**ADDENDUM NO. 3**

IRONDALE FIRE STATION No. 3

THIS ADDENDUM FORMS A PART OF THE CONTRACT DOCUMENTS. THE FOLLOWING CONDITIONS TAKE PRECEDENCE OVER ANY CONFLICTING CONDITIONS IN THE DRAWINGS AND SPECIFICATIONS. THE DRAWINGS AND SPECIFICATIONS ARE HEREBY AMENDED IN THE FOLLOWING PARTICULARS.

SHEET NUMBER  
**C3.0**

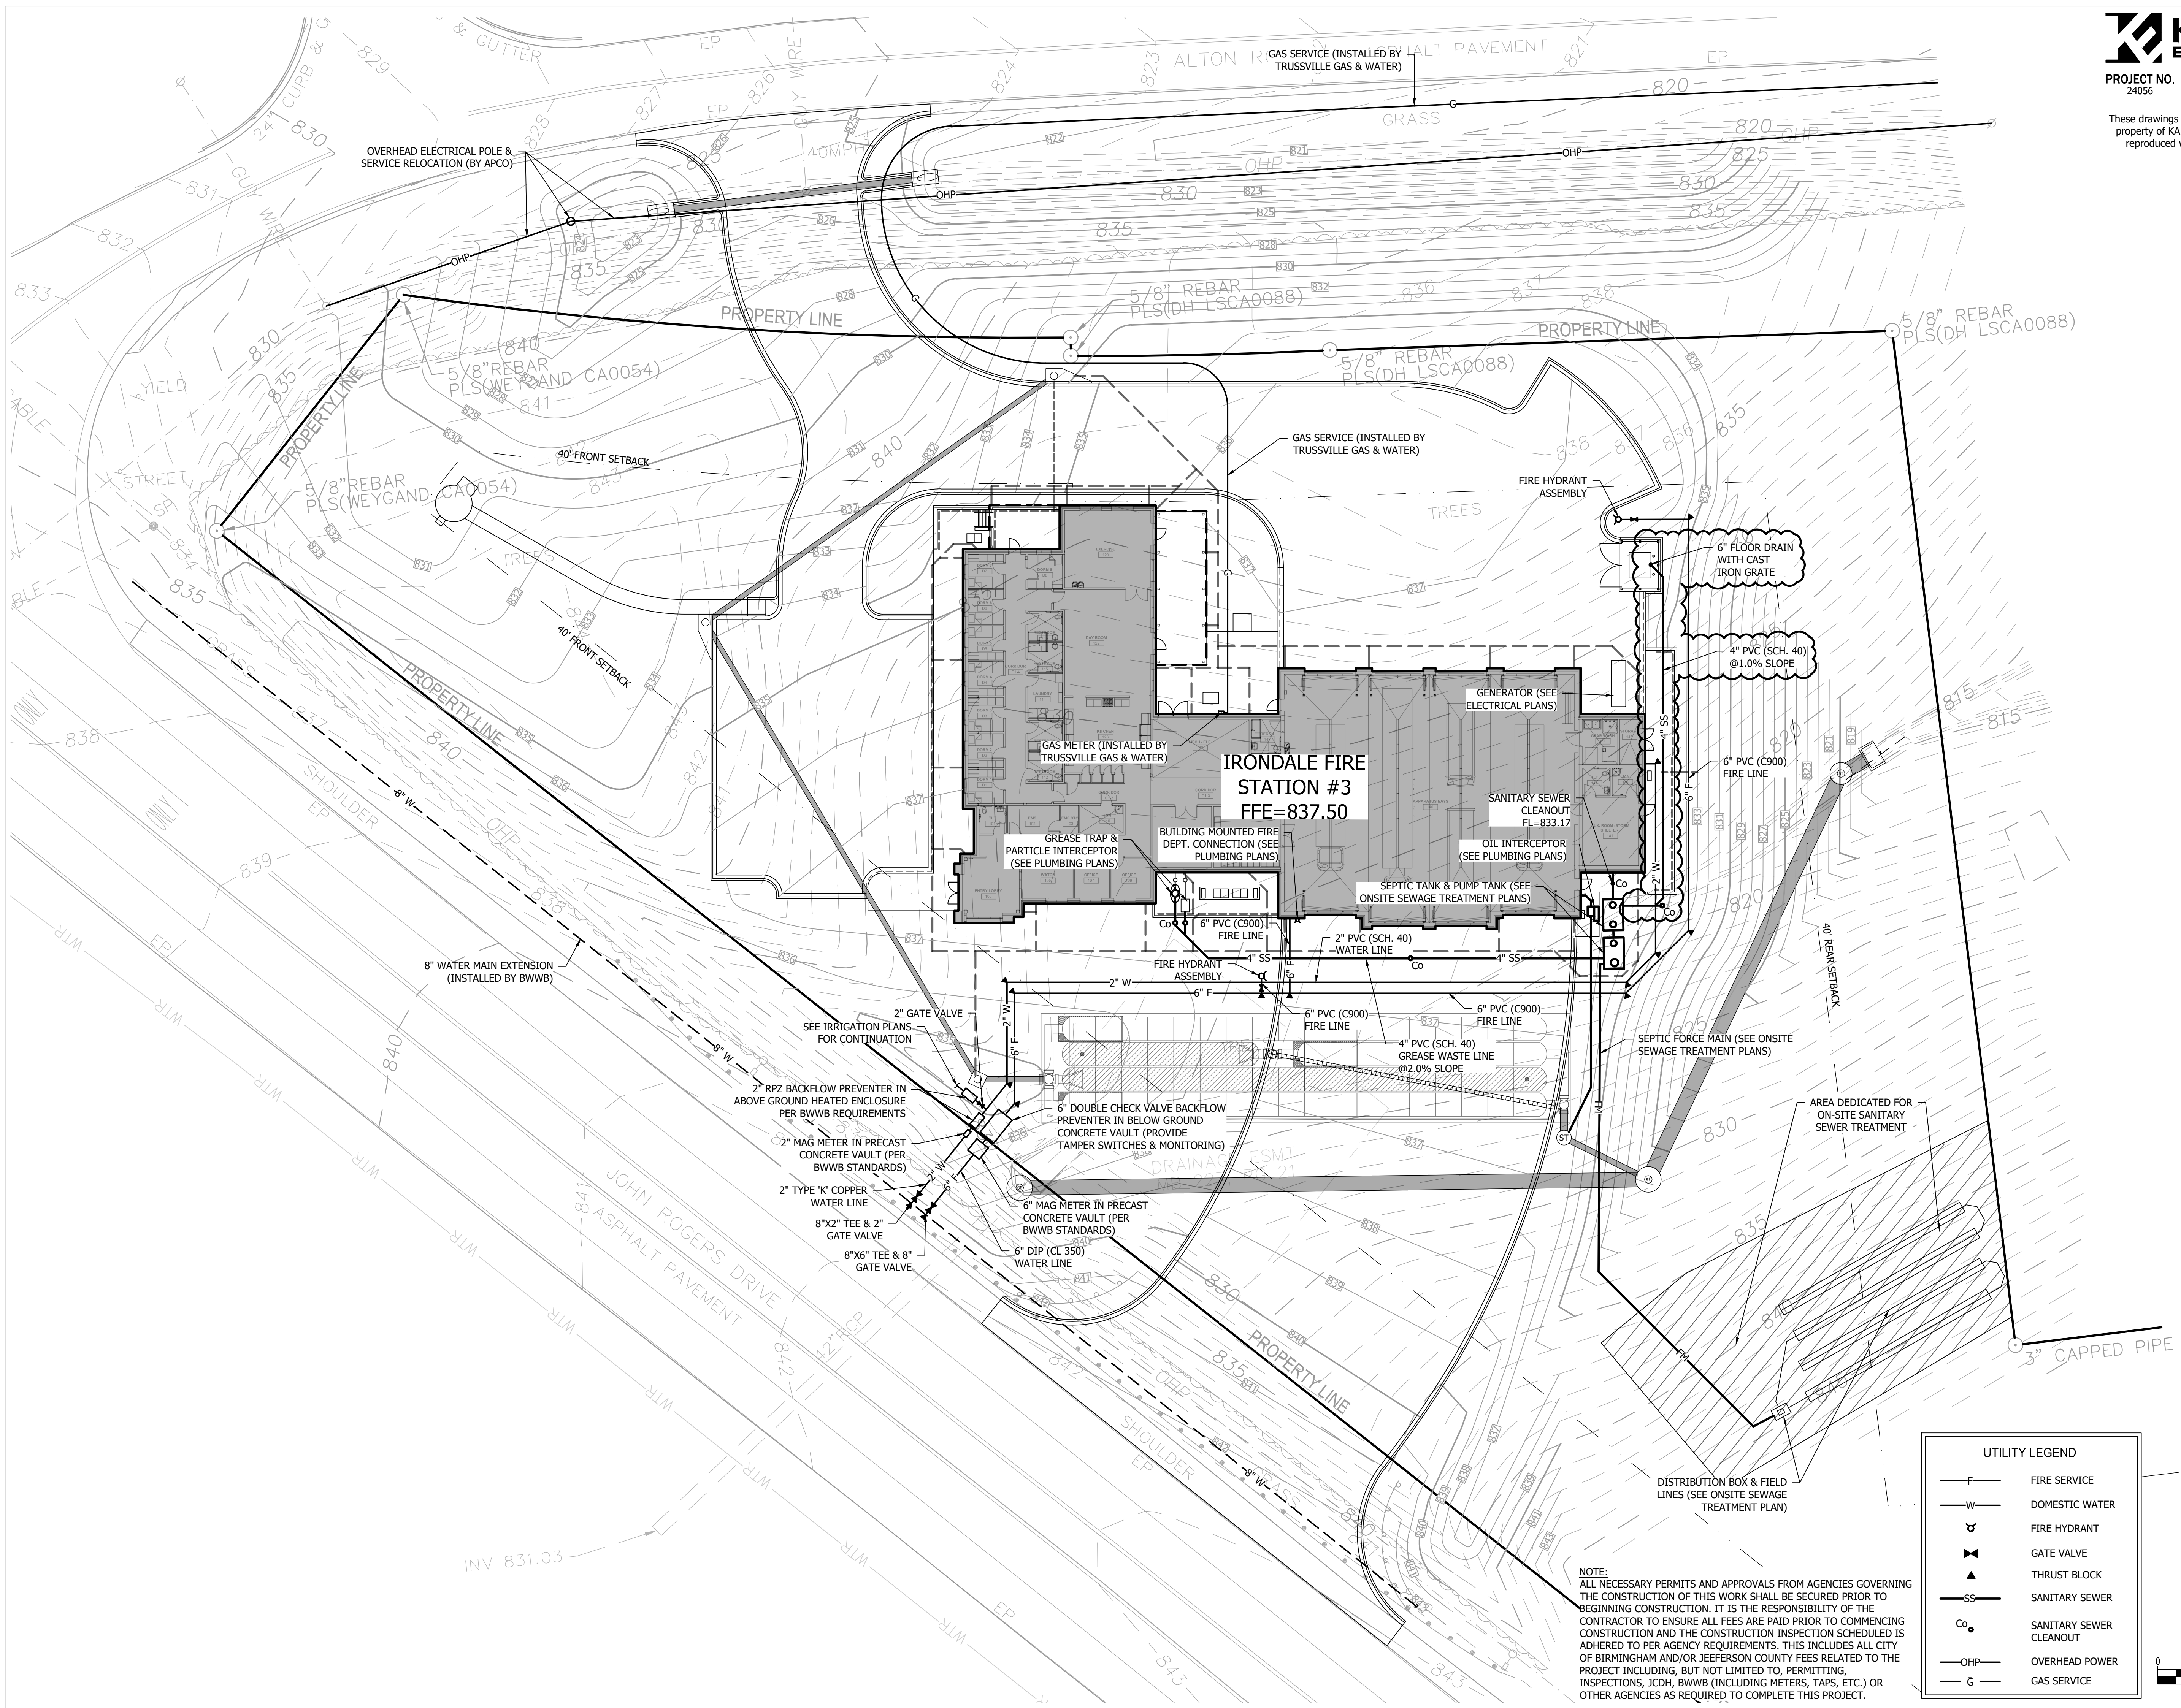
3. C2.1 Site Drainage Plan: Added dumpster floor drain and 4" sanitary line to septic tank
4. C3.0 Site Utility Plan:
  - a. Added Flexstorm Insert to grate inlet connected to underground detention system

- b. Added Notes 2-4 with City of Birmingham Stormwater Dept. requirements
5. C4.1 Erosion Control Plan – Intermediate:
  - a. Removed row of silt fence on the uphill side of the onsite sewer treatment area. This should also be removed from the initial phase (sheet C4.0).

26. *The civil drawing C3.0 calls out for the underground fire main piping to be C-900 plastic piping but the specification section (331416) Part #3, 3.2 letter J calls for the piping to be ductile piping. Please, advise on which pipe to be installed for this project.*

Answer: Ductile iron pipe will be required from the tap to the backflow preventer and C-900 pipe can be for fire service piping beyond the backflow preventer

SHEET NUMBER  
**C4.1**

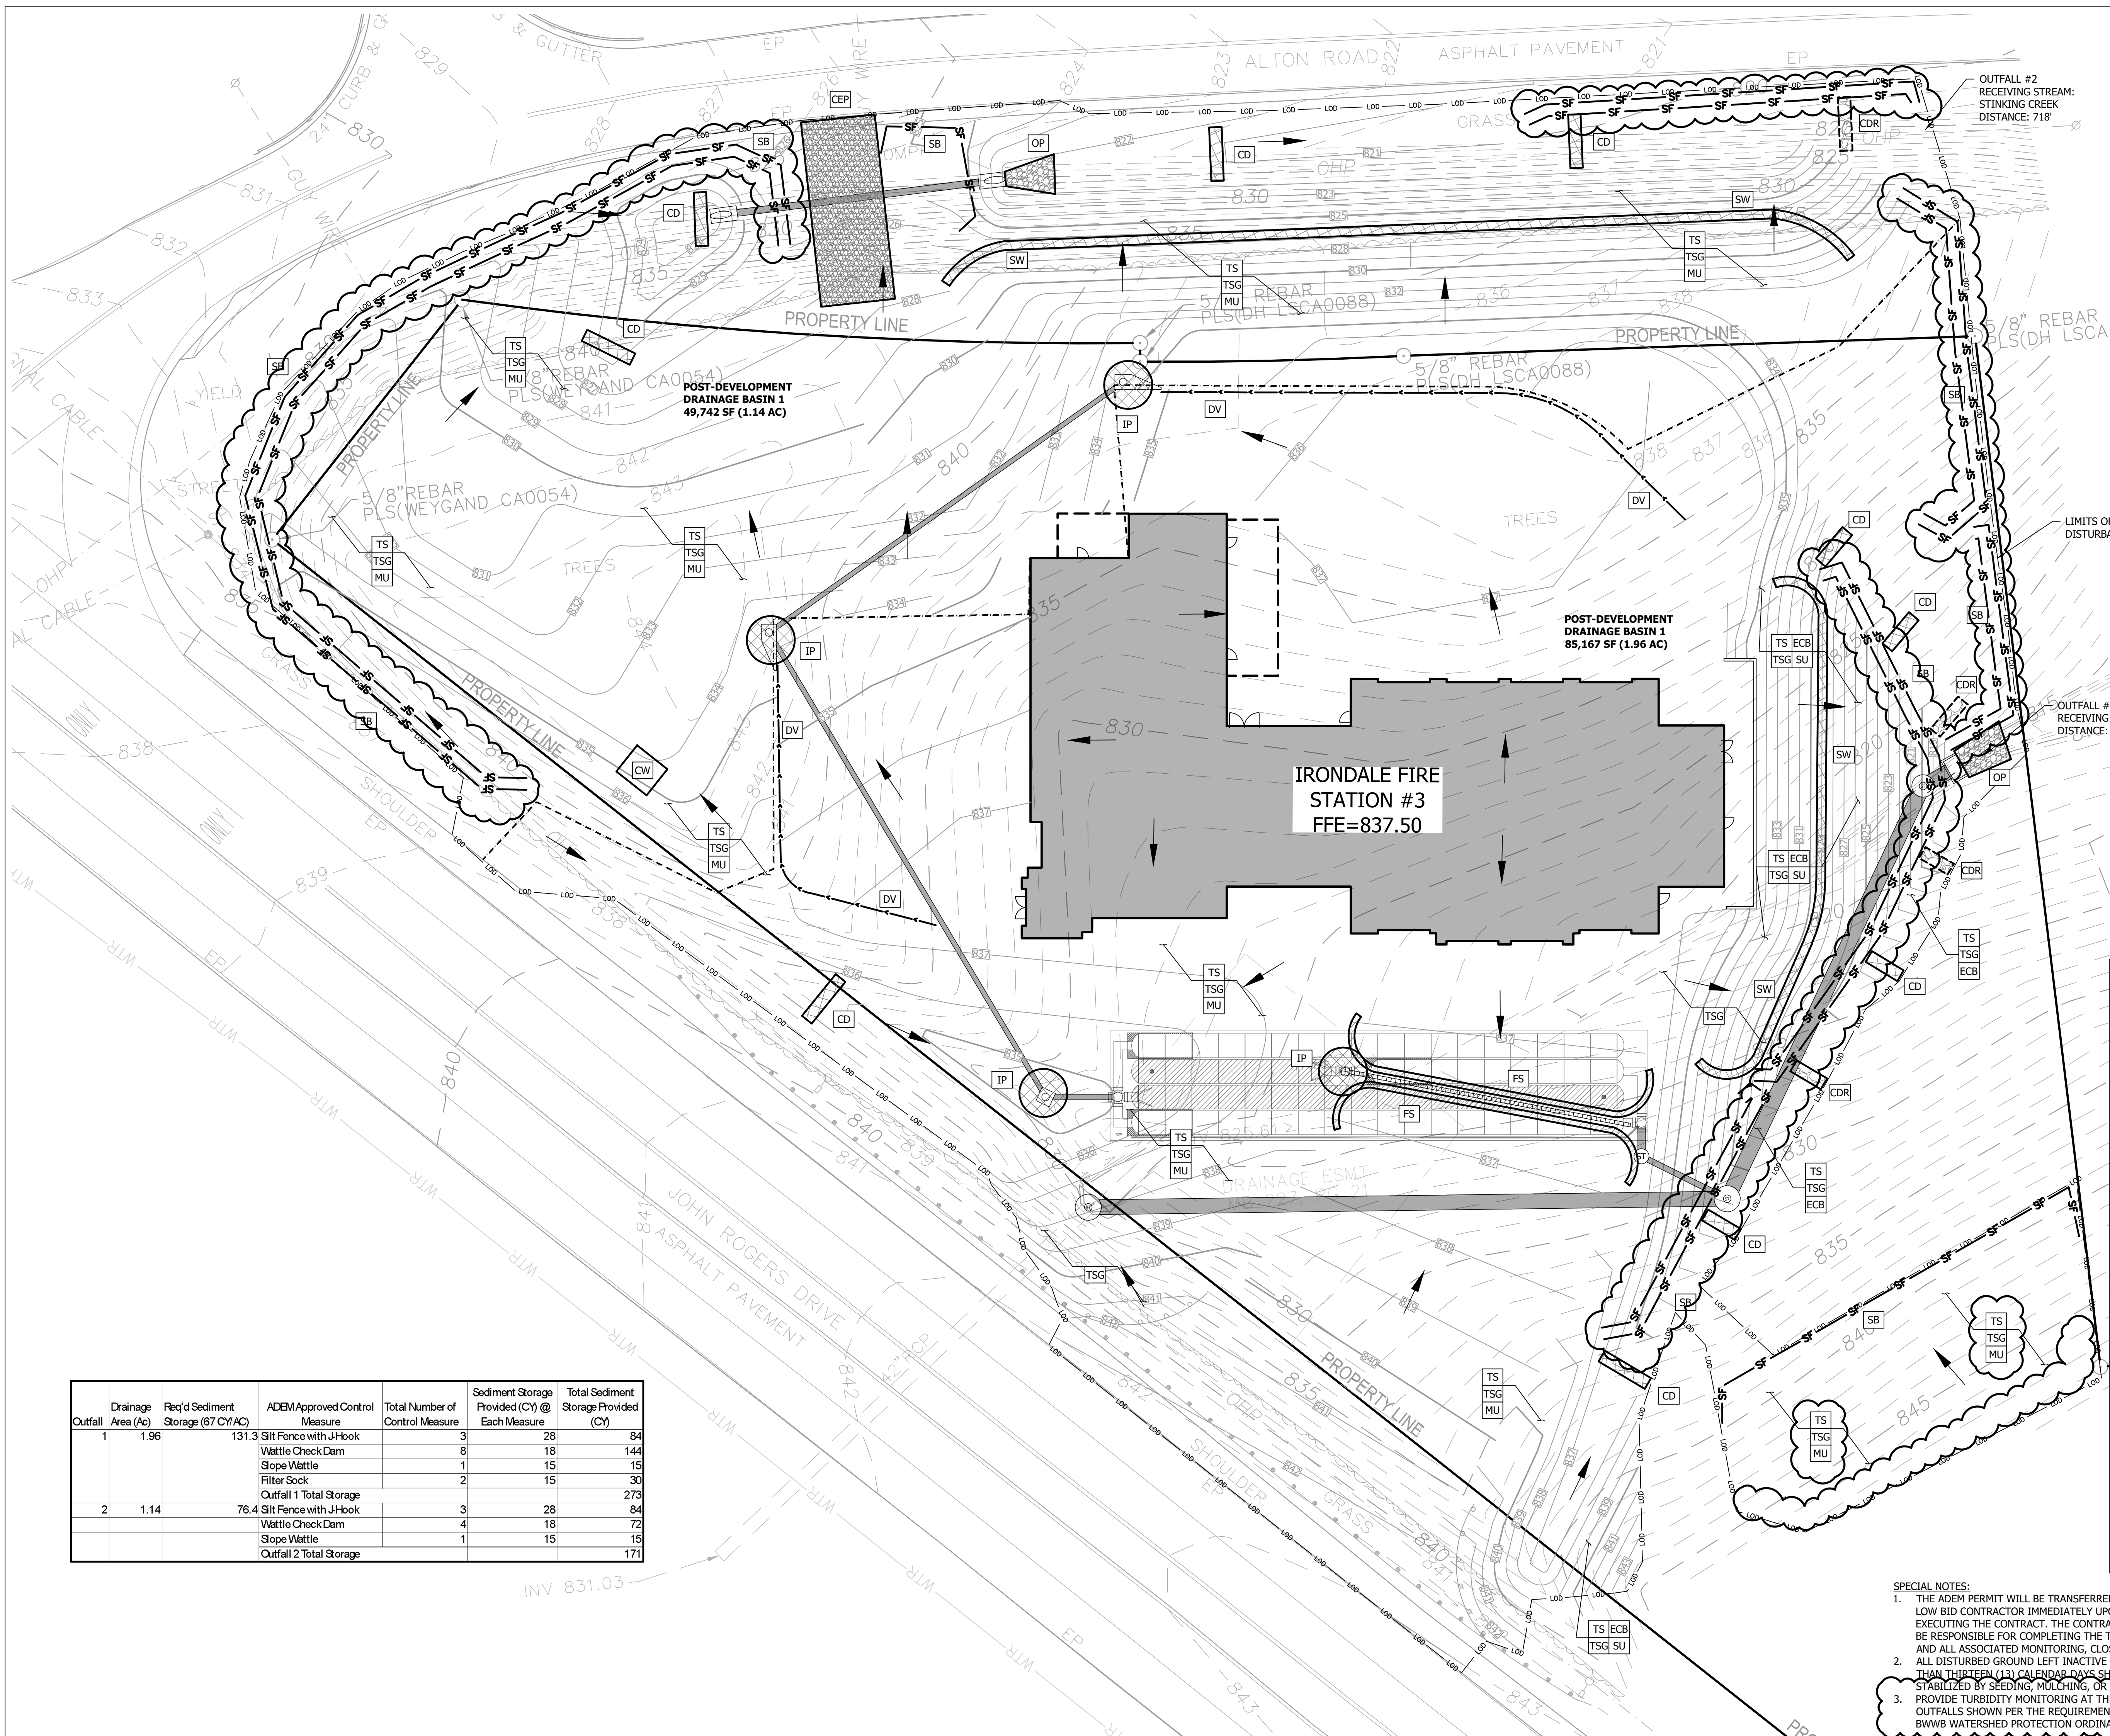
- b. Added topsoil, temporary seeding, and mulching to the onsite sewer treatment area

- c. Changed from single to double row of silt fence around the perimeter of the site
  - d. Added special note 3 regarding turbidity monitoring requirements
